Origination Form
Proposed Revisions to a Standard Plans Index

Originator:	Turley, Joshua	Index Number:	455-031
Date:	5/15/2025	Sheet Number(s):	Sheet 1
E-mail:	Joshua.Turley@dot.state.fl.us	Index Title:	30" SQUARE PRESTRESSED CONCRETE PILE - HIGH MOMENT CAPACITY

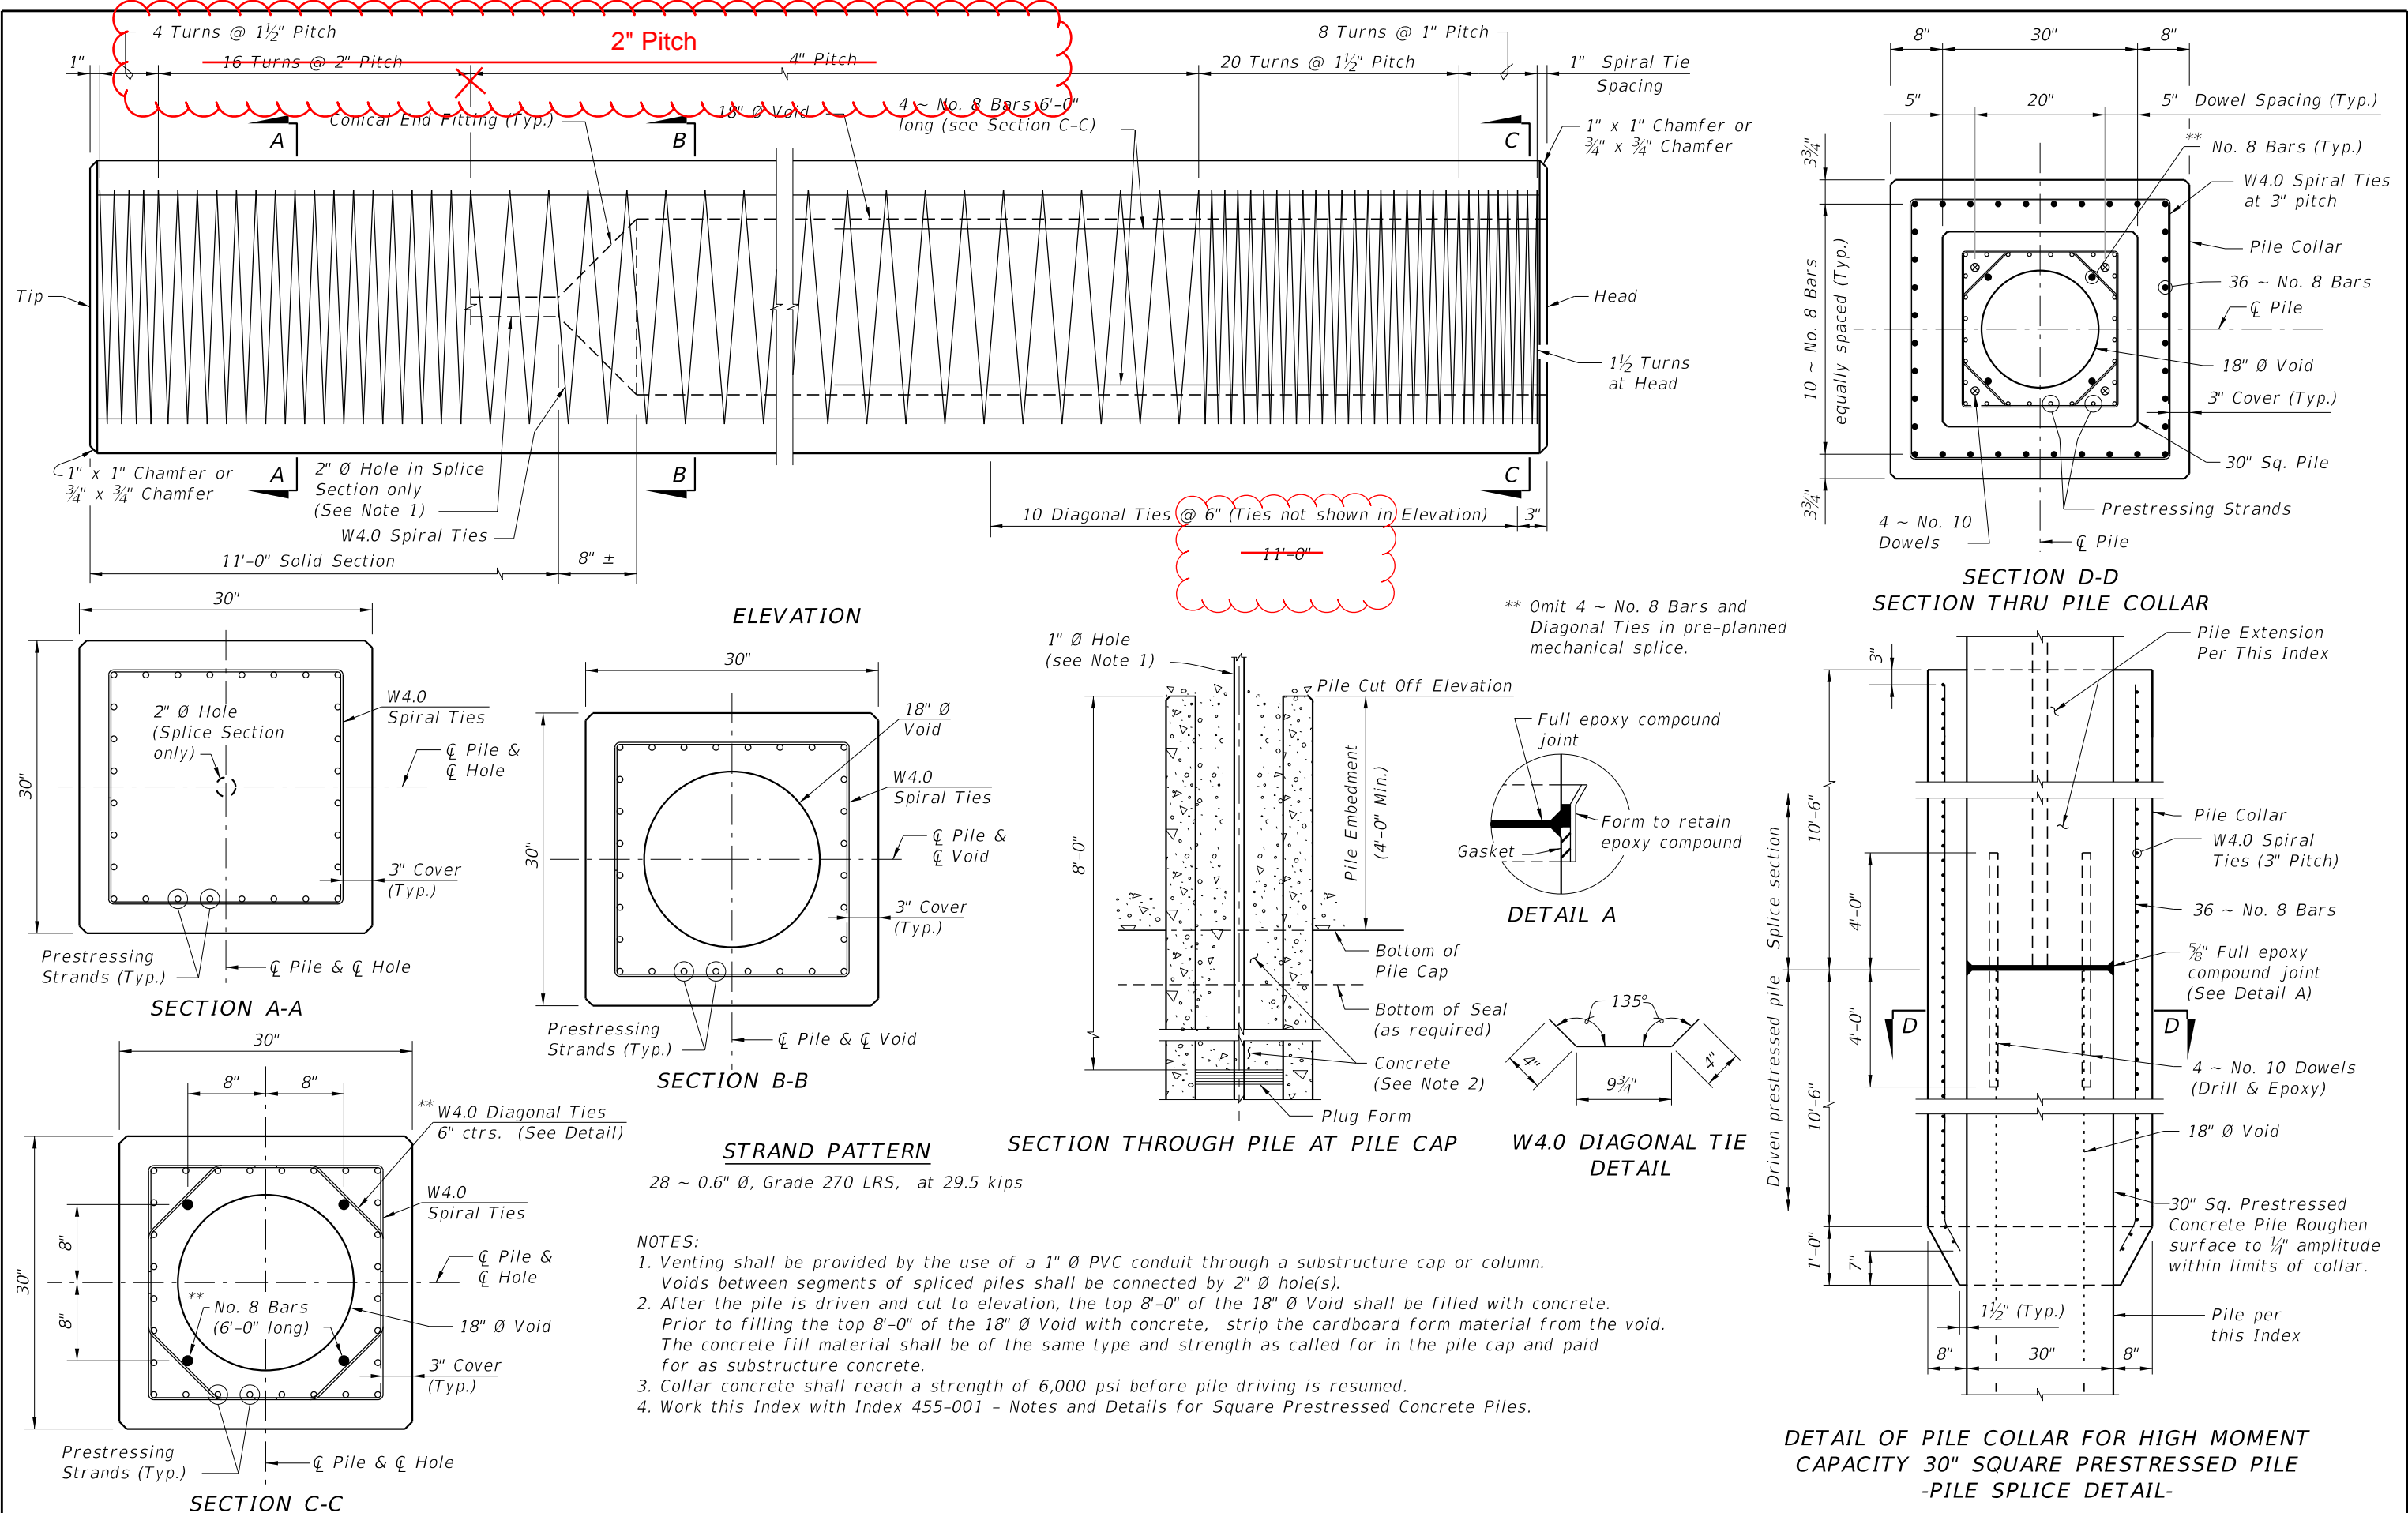
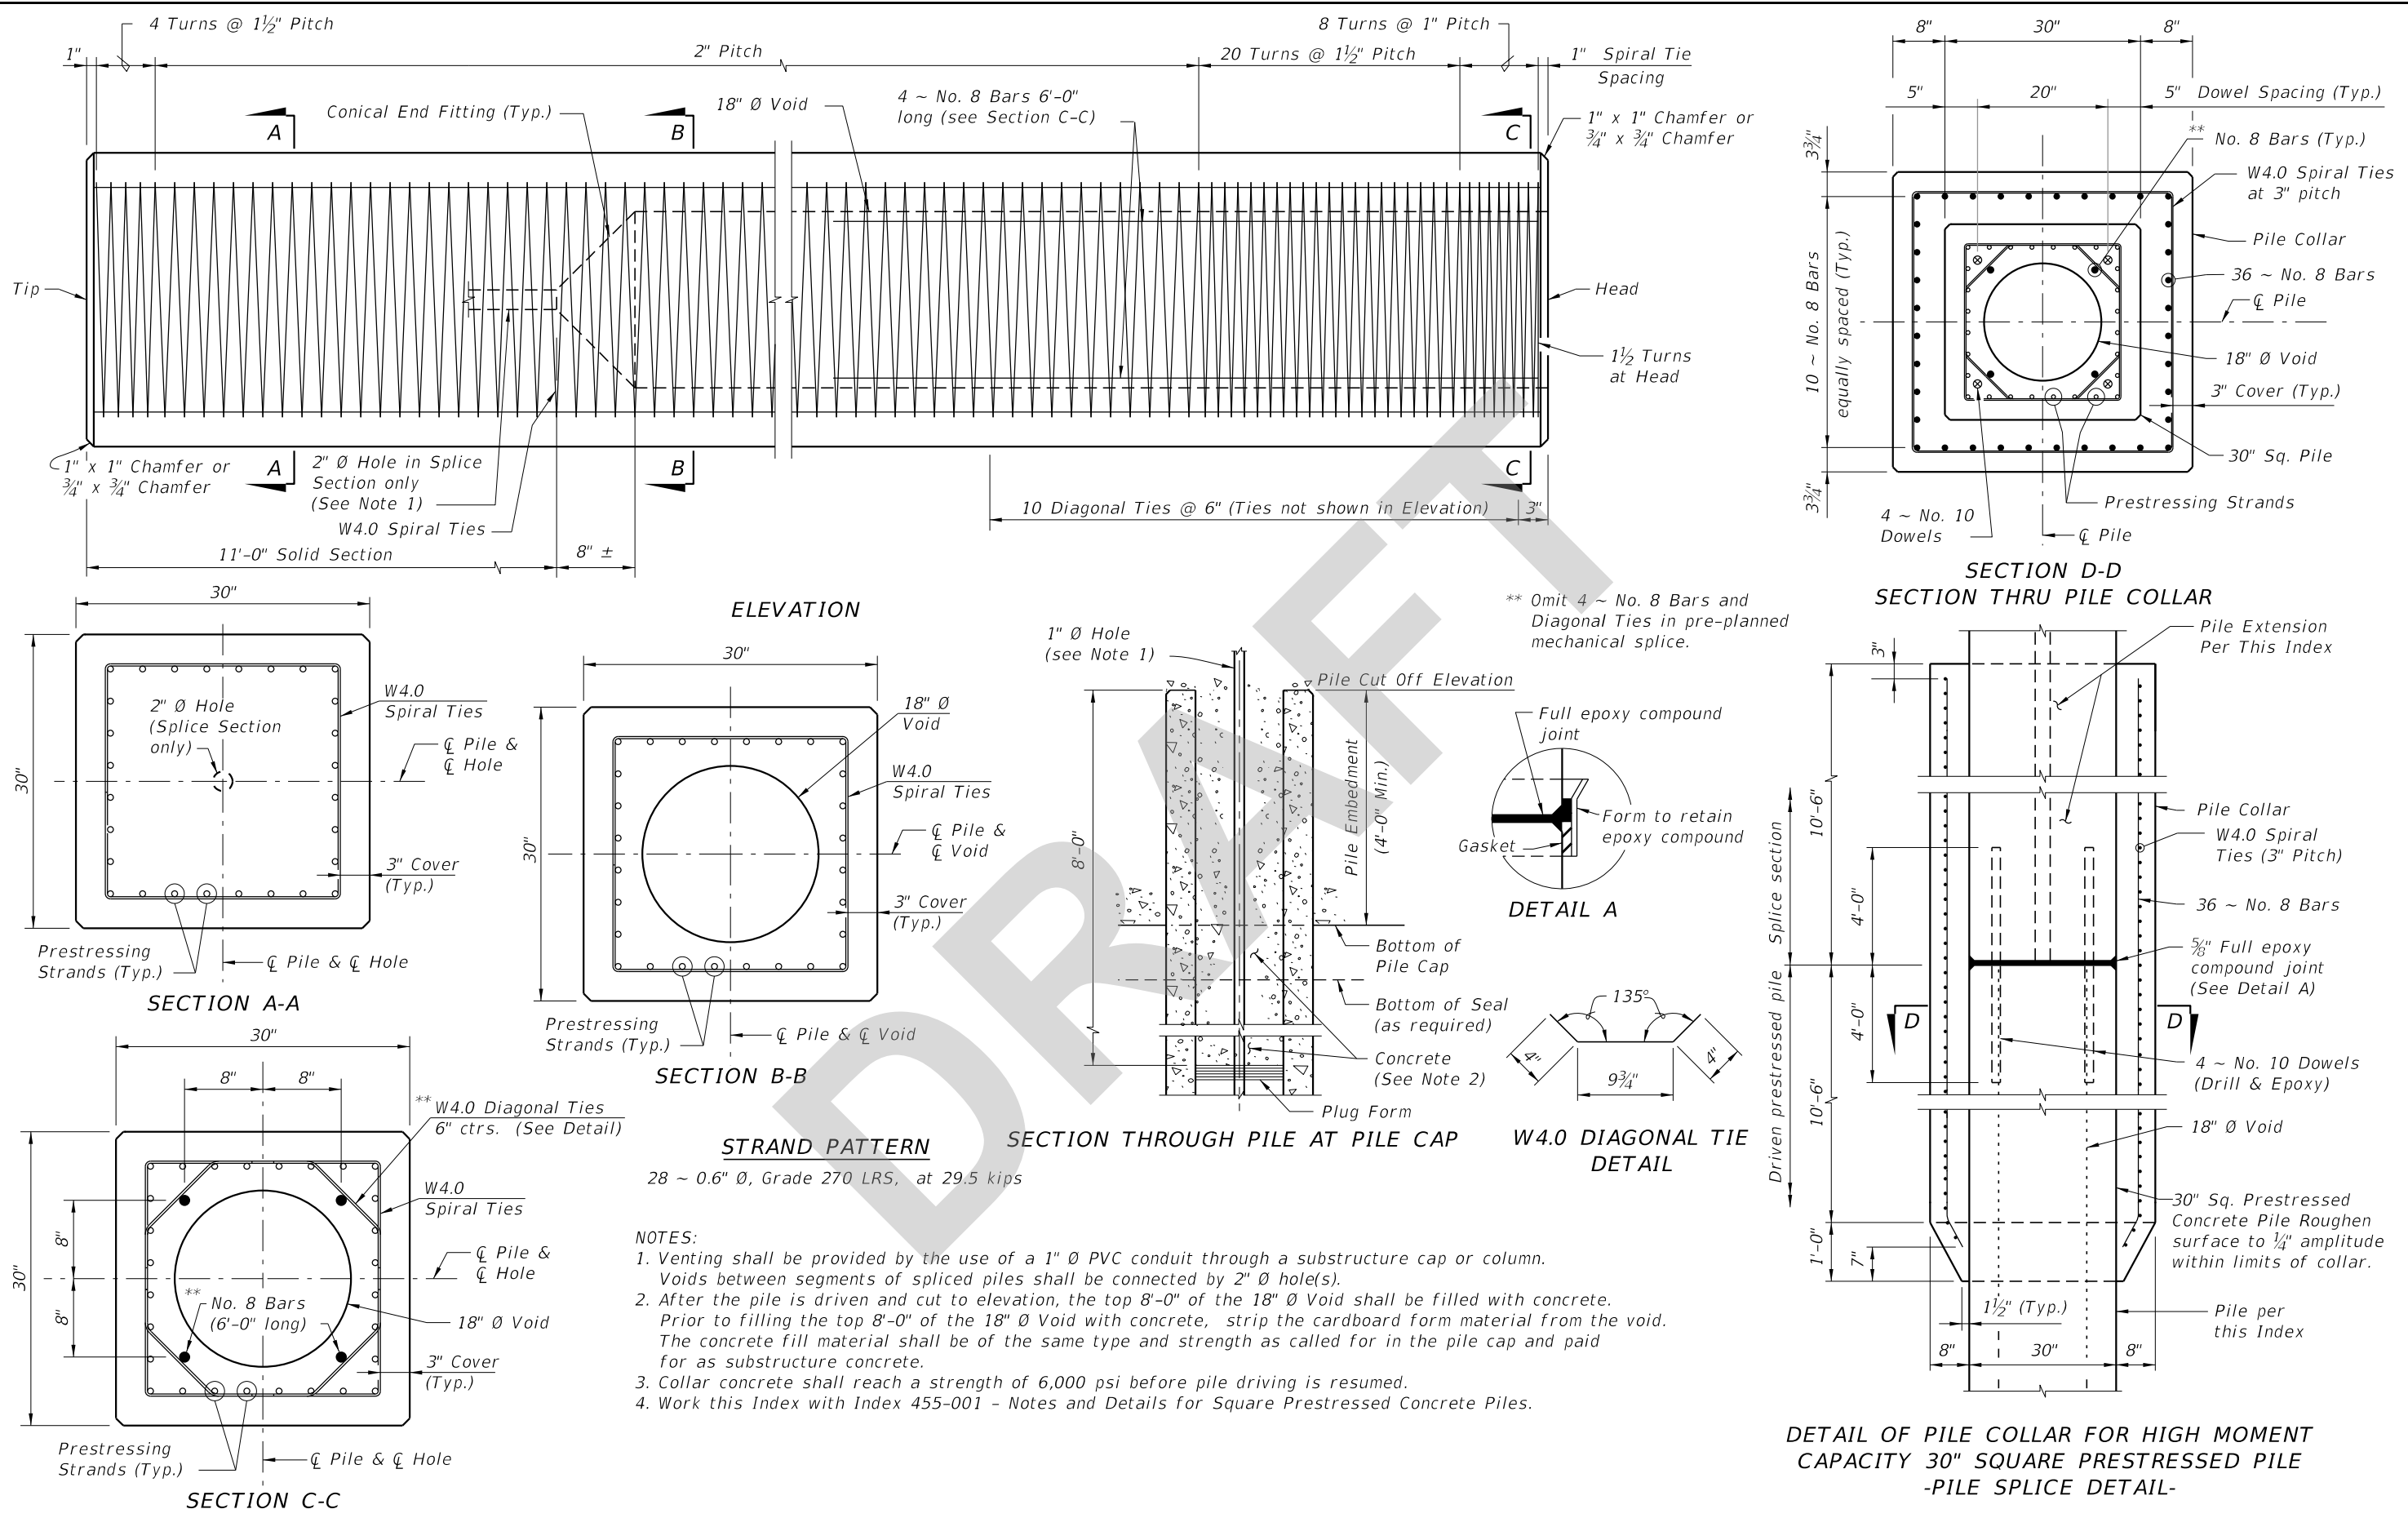
Sheet 1: Changed pitch spacing for spiral ties and removed errant 11' dimension which was a CAD error.

Vertical cracking has been observed in hollow core prestressed concrete piles, including 30-in. voided square HMC and conventional piles, and 60-in. hollow cylindrical piles, during installation and service. To address cracks frequently occur within the 4" stirrup pitch zone, a reduction in stirrup pitch to 2" is proposed to help mitigate cracking in these areas.
